Subject: Lodi Energy Center (08-AFC-10)
Data Response Set 2, Responses to CEC Staff Data Requests 56B-74, and
Workshop Queries 1 and 2

Data Response Set 2
(Responses to Data Requests 56B through 74
and Workshop Queries 1 and 2)

LODI ENERGY CENTER

Data Responses, Set 2 **(Response to Data Requests 56B to 74 and Workshop Queries 1 and 2)**

FIGURE DR73-1
LEC FOGGING FREQUENCY CURVE
LODI ENERGY CENTER
LODI, CALIFORNIA

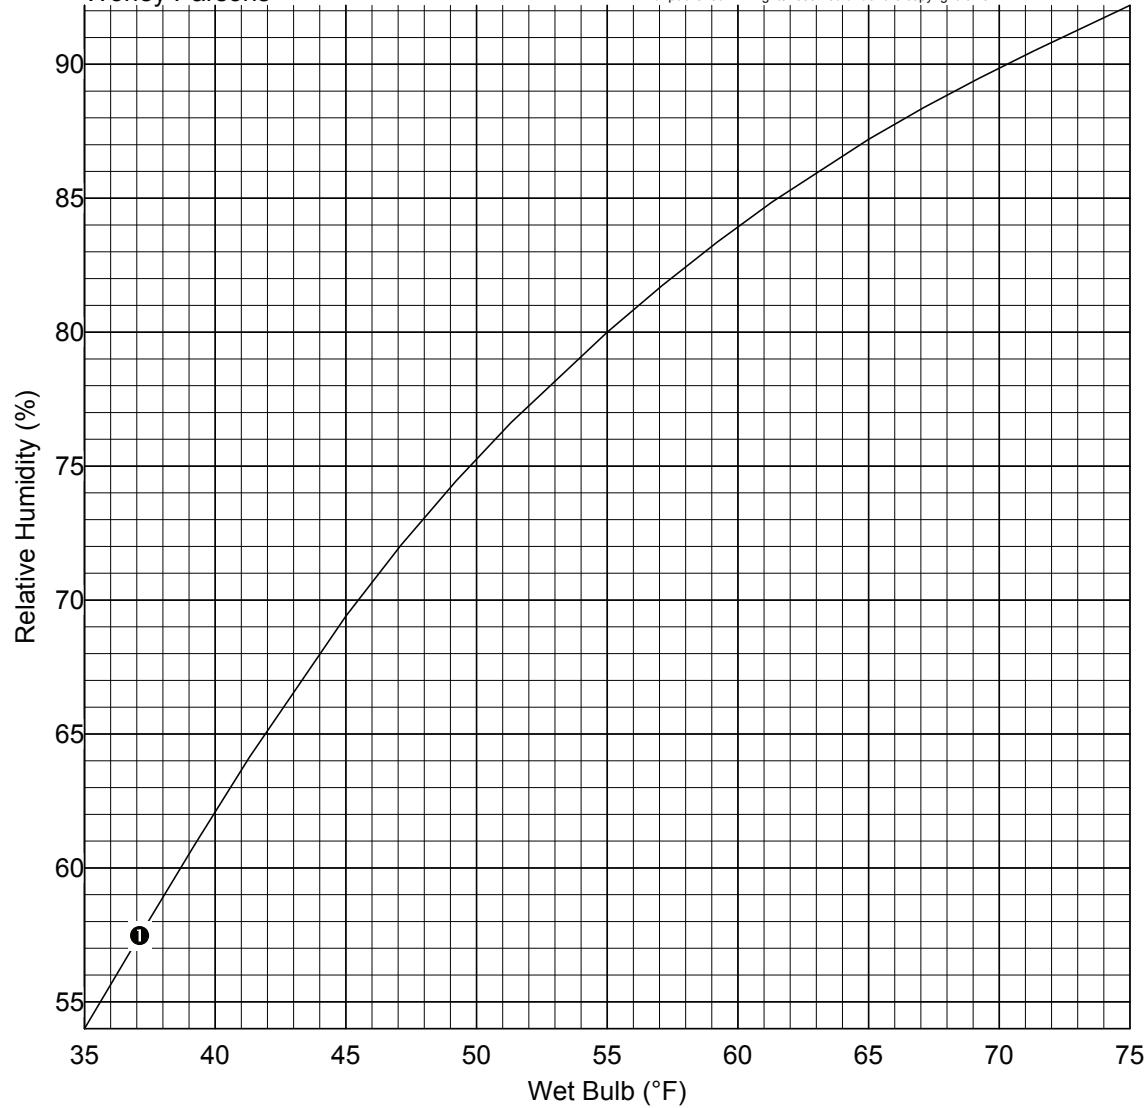
73. Please provide the cooling tower manufacturer and model number information and a fogging frequency curve from the cooling tower vendor, if available, that corresponds to the altitude of the project site.

Response: A fogging frequency curve including the cooling tower manufacturer and model number information is provided as Figure DR73-1.
